NCC Public Comment Draft Response Sheet

Organisation: Australian Institute of Architects

Submission by Australian Institute of Architects to
ABCN NCC 2022 Public Consultation Drafts. July 2020

Clause/Figure/Table: H8P1 Livable housing design - Exemptions

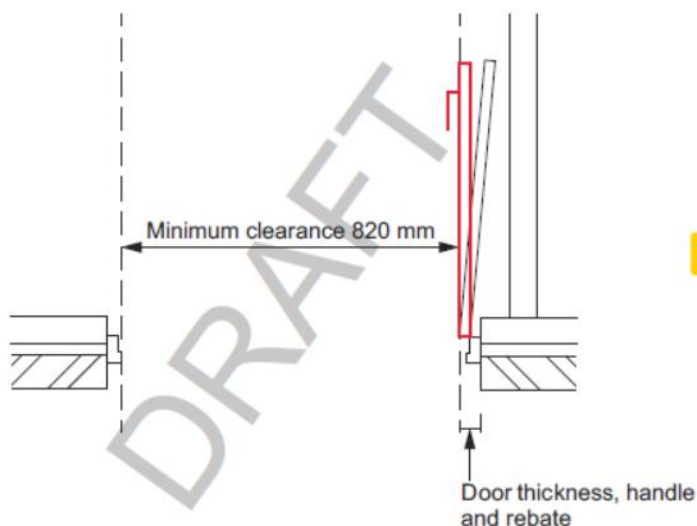
Additional text to be inserted below the exemptions: "However, it is not the intention of these exemptions to ordinarily deem a car space under a house or below as exempt, and especially including one on a flat site."

Steep sites, small sites, or other local factors where a high floor level is required (eg flood prone areas) are reasonable to consider for exemptions. However 'gaming' of the standards should not be encouraged and every effort made to comply with the intent of the standard.

Clause/Figure/Table: Figure 4.2b

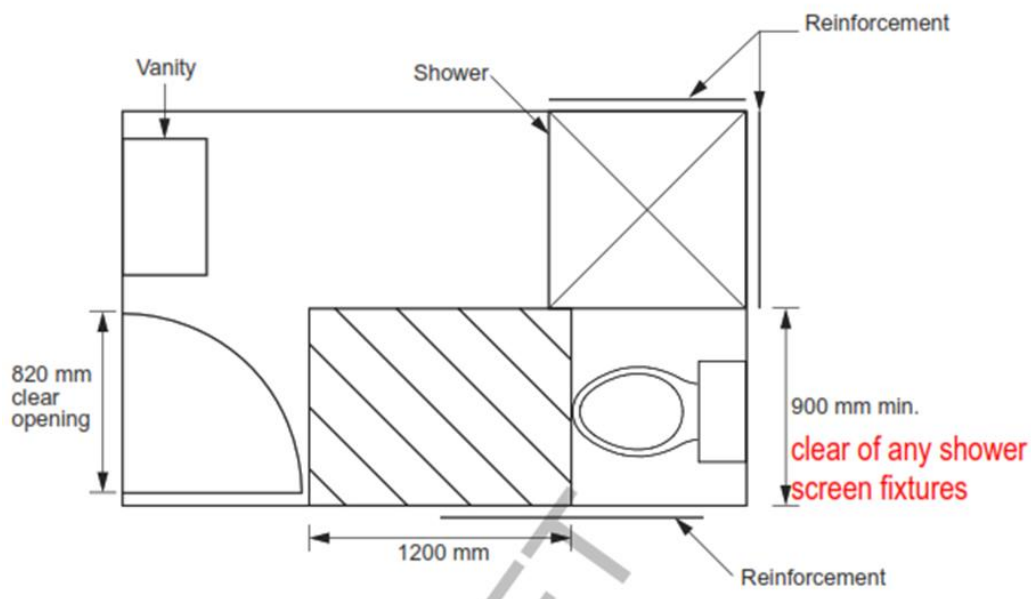
Add text: "clear of any shower screen fixtures" to Figure 4.2b as shown:

Required for clarity

Clause/Figure/Table: Figures 6.2 (c)

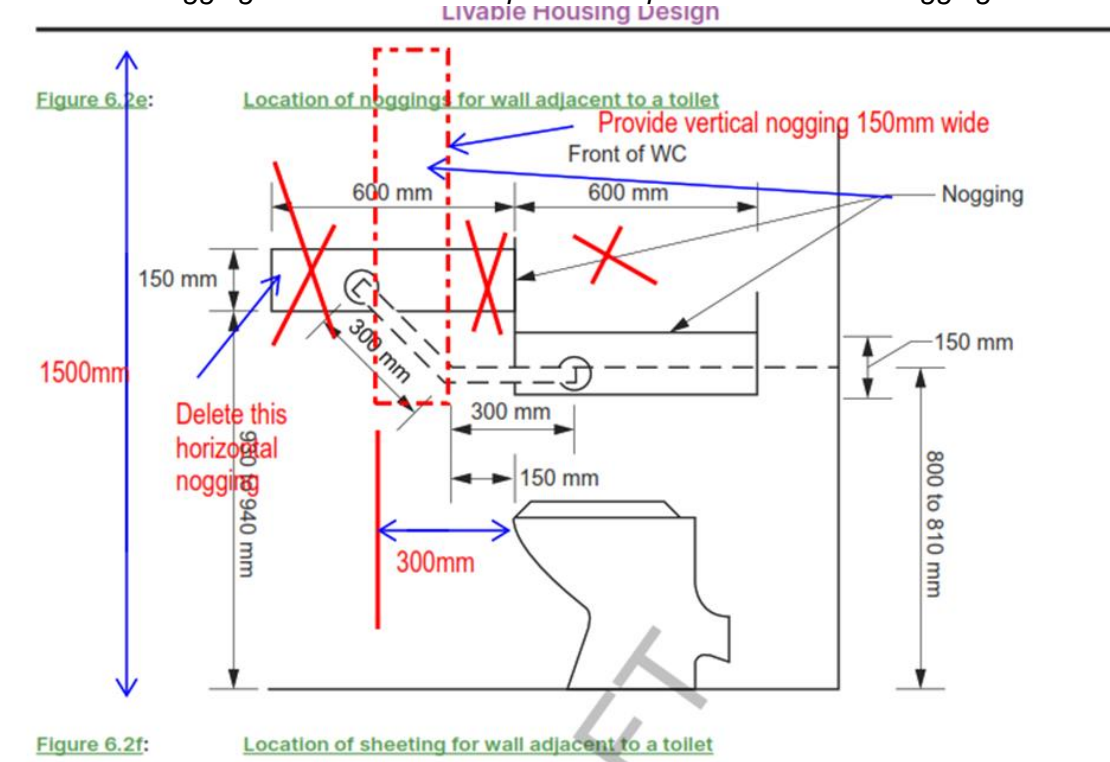
The wall reinforcement and noggging location diagrams shower areas need to be extended.

The areas shown are insufficient in coverage for larger or more extended rail systems involving rails of greater dimensions or multiple rails/ hand holds.

Clause/Figure/Table: Figures 6.2 (e)

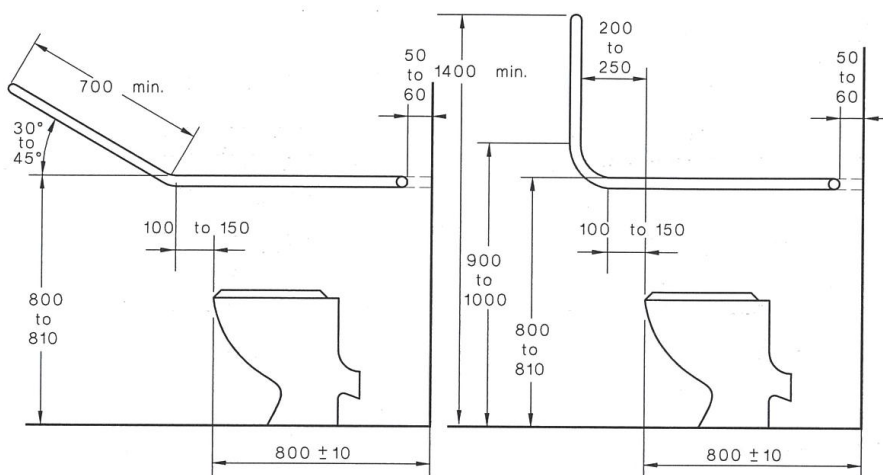
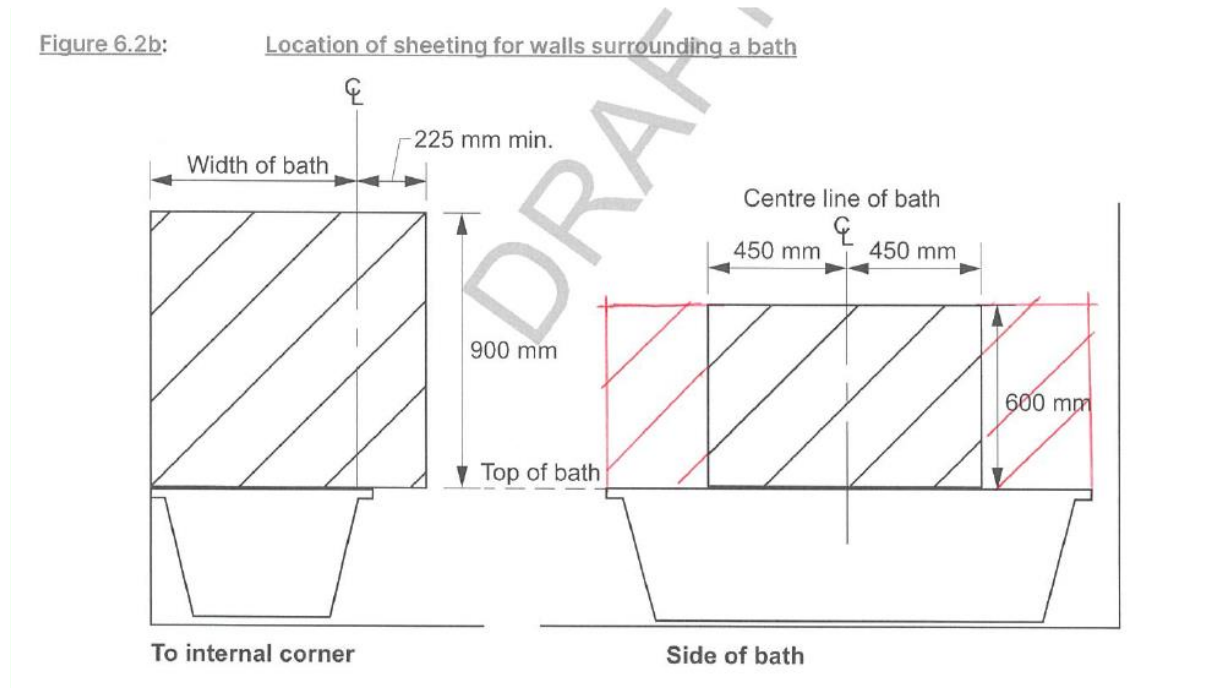
Delete the nogging forward of the WC pan and replace with vertical nogging as shown:

The 600mm nogging option forward of the pan should be redesigned to allow for the most commonly used 90 degree grabrail available in the market in lieu of the short angle grabrail shape which is shown in the document which is hard to source. See most commonly available grabrail size shown below (AS1428.1).

Clause/Figure/Table: Figures 6.2 (b), (d) and (f)

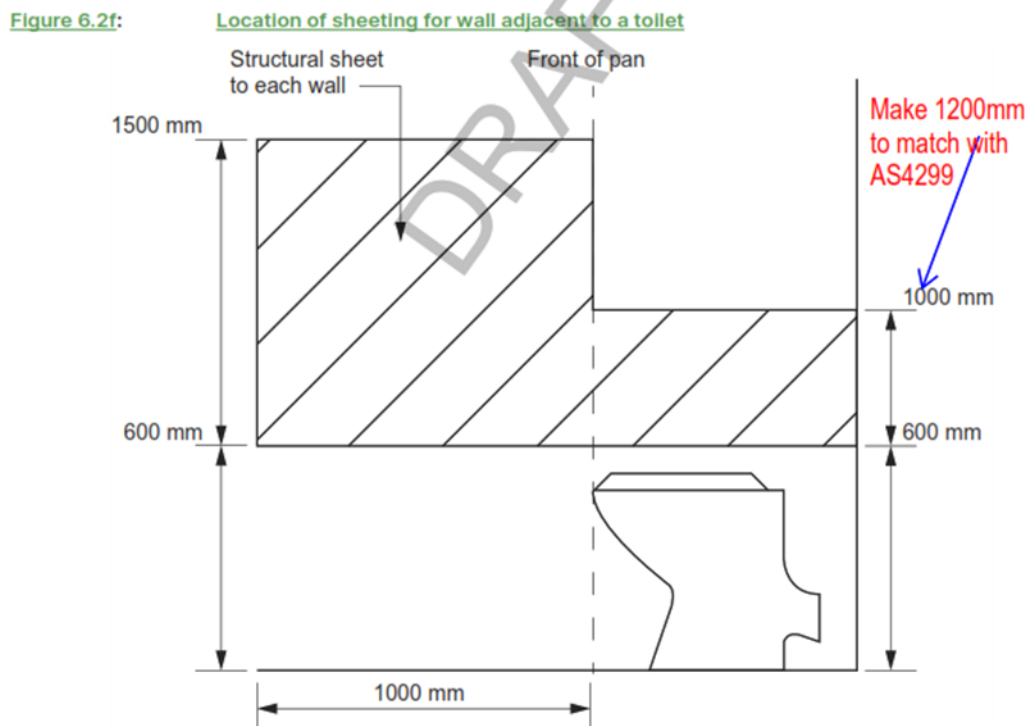
The indicated areas of sheeting in the schematic diagrams should accord with AS4299 or better.

All sheeting areas in the document are based on Livable Housing Design Guidelines that were not based on any research. The AS4299 has the recommended area of sheeting which is slightly different and for consistency the AS4299 version of sheeting for WC pan, shower and bath tub should be used. We note there may be a more recent and more rigorous standard such as the National Disability Insurance Scheme's (NDIS) Specialist Disability

Accommodation (SDA) Design Standard (2019) which specifies that for 'improved liveability' and 'robust' design categories, "Internal side of full sanitary facility shall have wall reinforcement which consists of minimum 12mm thick sheeting, from FFL [finished floor level] and extending to a height of minimum 2100mm from FFL." (pp 38).
